**Amendments to the Drawings:**

## R E M A R K S

FIG. 2

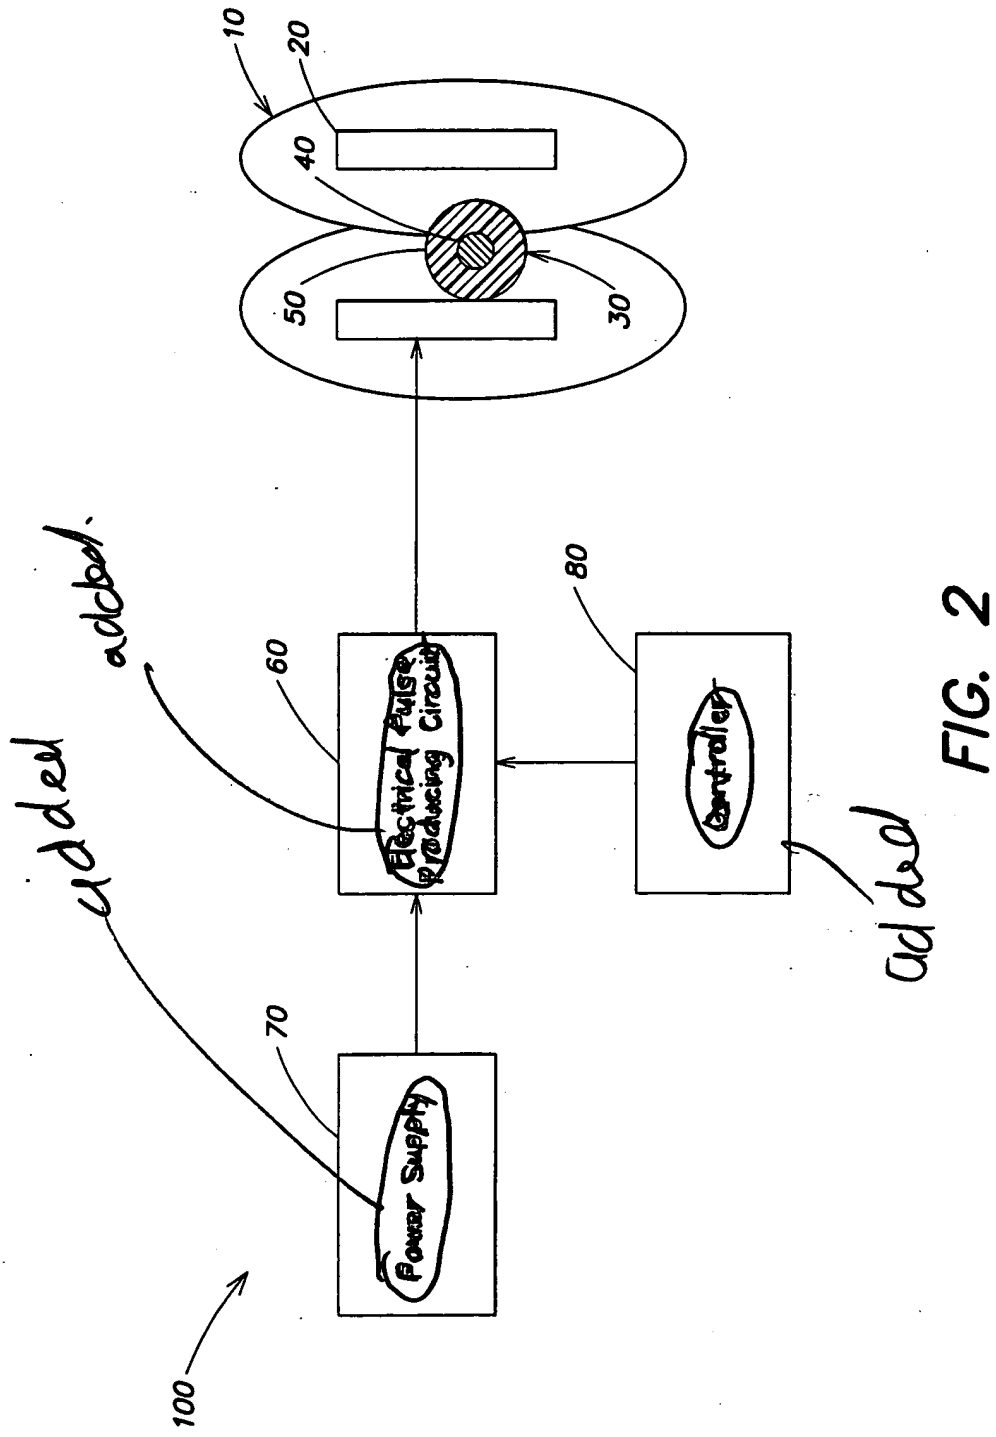
Fig. 2 has been amended to include figure legends in boxes 60, 70 and 80.

Figure 2 of the drawings was amended to add figure legends to boxes 60 (Electrical Pulse Producing Circuit), 70 (Power Supply) and 80 (Controller). Support for these amendments to figure 2 are already in the specification. Specifically, for box 60, see page 12, lines 24-25 and for boxes 70 and 80, see page 12, line 31 of the present specification. No new matter has been added.

Attached is a replacement sheet of formal drawing for Fig. 2 and an annotated sheet for Fig. 2 showing changes in red.

The new set of formal drawings submitted concurrently herewith incorporates the above-described amendments to Fig. 2.
